TSB00-0401

## TECHNICAL SERVICE BULLETIN

Fire Trucks with DDEC (Detroit Diesel) Engine AND Involved in Recall Campaign #RSB 99V-010 or #RSB 99V-010A.

**FIG. 4-1**

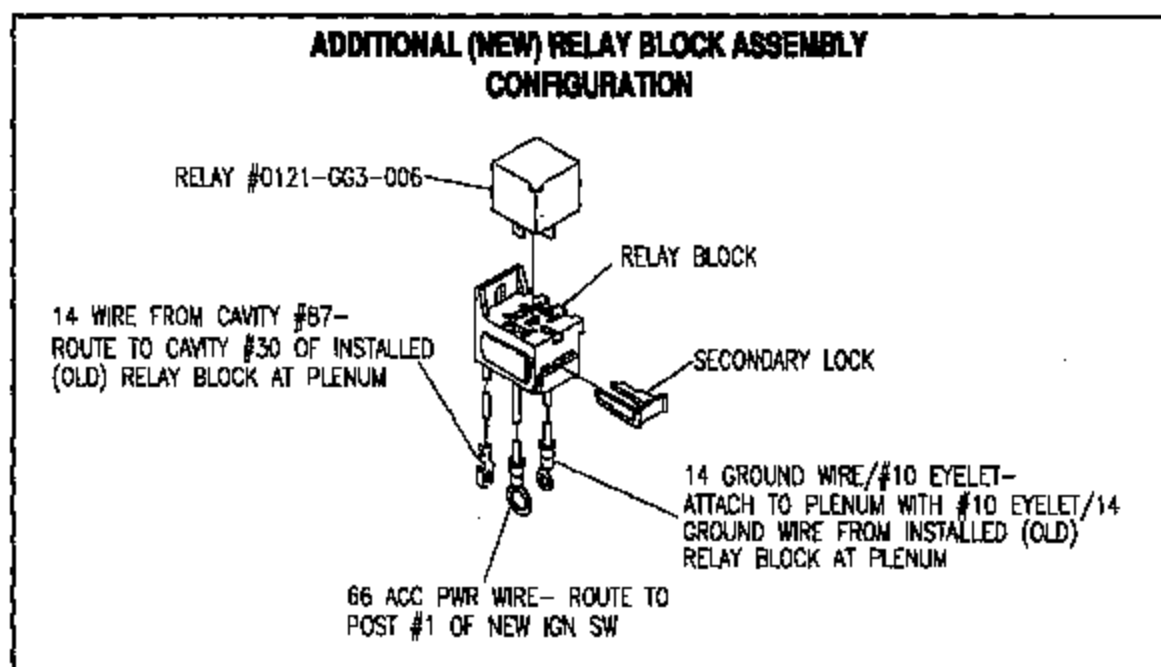
'Engine' and 'Check Engine' Warning Lights Illuminate When Battery Master Switch is Turned On and Then Turned Off; May also experience 'Engine Run-On'.

Voltage Signal Present at the Engine ECU Causing Activation of the ECU "Wake-Up" Signal.

1. Chock wheels.
2. With the cab stationary (NOT tilted), disconnect the batteries.
3. Locate the relay block, previously installed at the plenum (per RSB99-V-010 or RSB99-V-010A).
4. Remove secondary lock and relay from installed relay block.
5. De-pin circuit #DD440 from cavity #30 of the installed relay block.
6. Pin the #DD440 circuit (de-pinned from installed relay in step #5) into cavity #30 of the (new) relay provided in kit #000401.

Perform wiring rework to prevent voltage transmission.

Install relay block and perform wiring rework. Necessary to remove ignition panel.

**Note:** Relay and secondary lock should be removed from the new relay block prior to pinning. Refer to FIG. 4-1.

0120-GG5-823

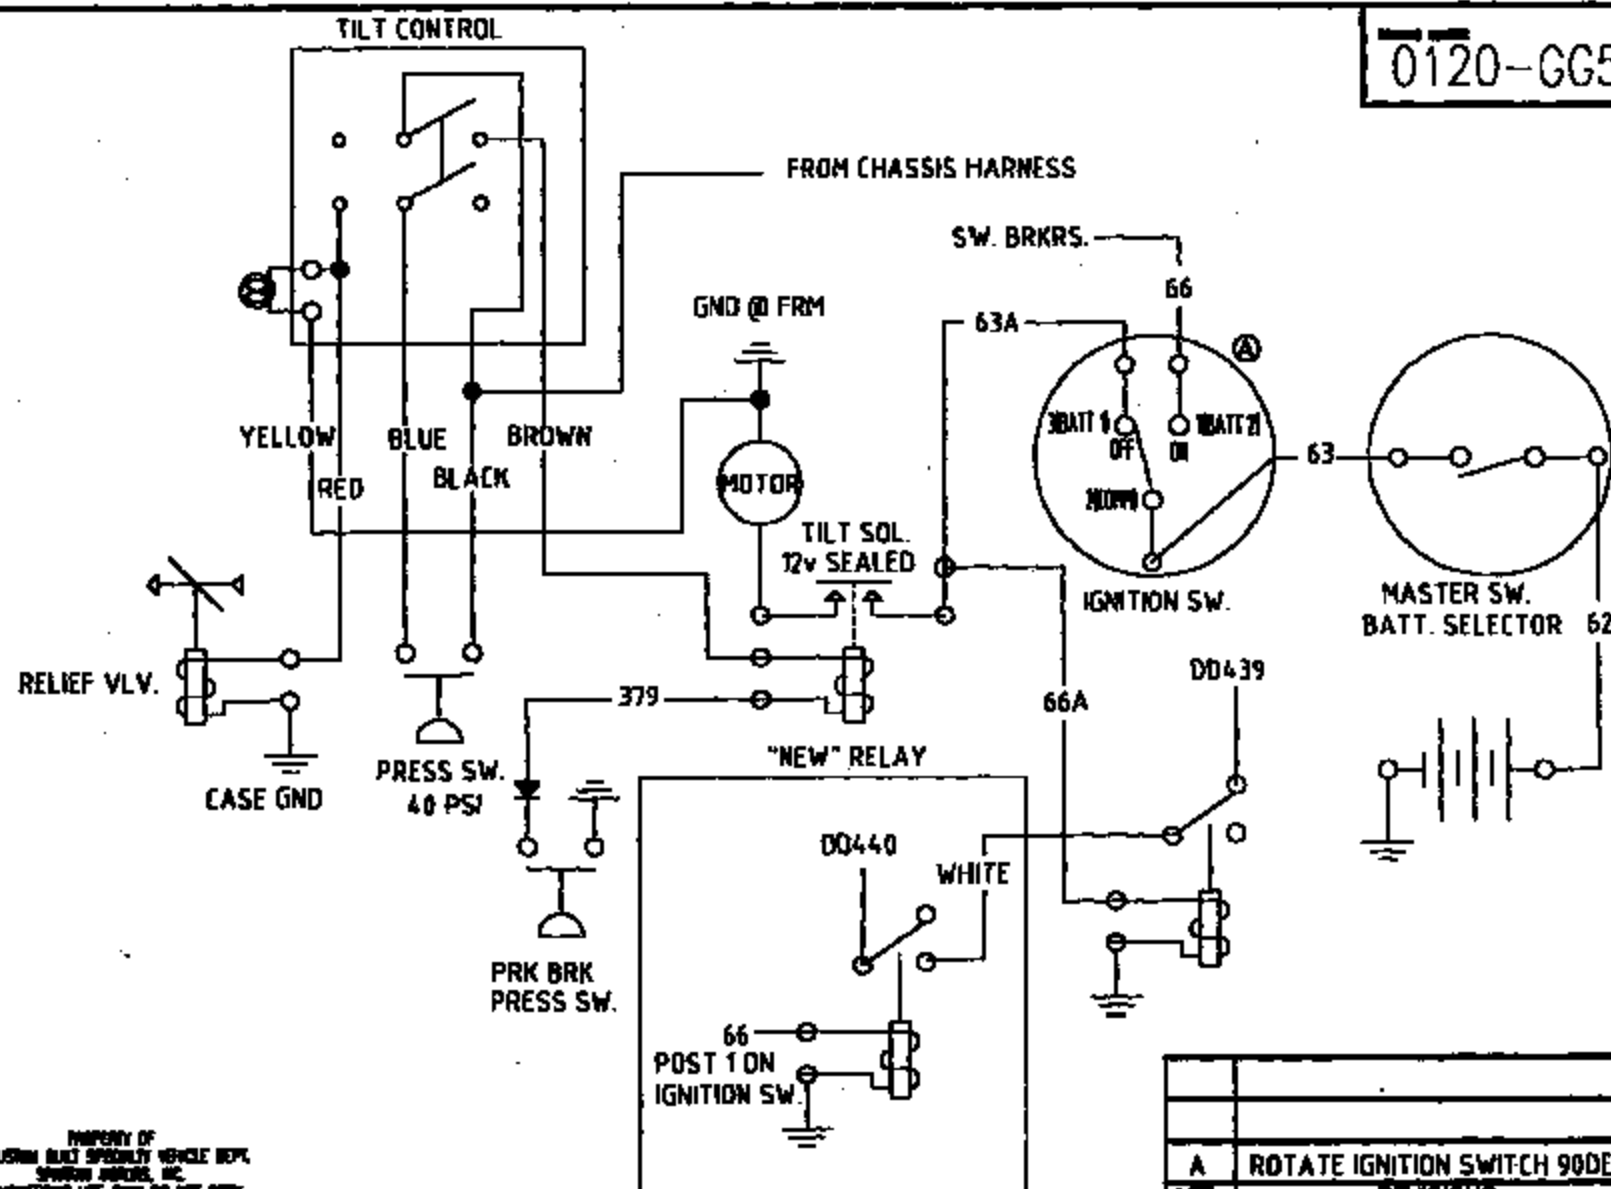
14. Attach the 14 ground wire (with #10 eyelet) of the old relay, and the 14 ground wire (with #10 eyelet) of the new relay, to the plenum at the existing hole using the screw removed in step #13. Refer to attached wiring diagram in drawing #0120-GG5-823 Rev. A.
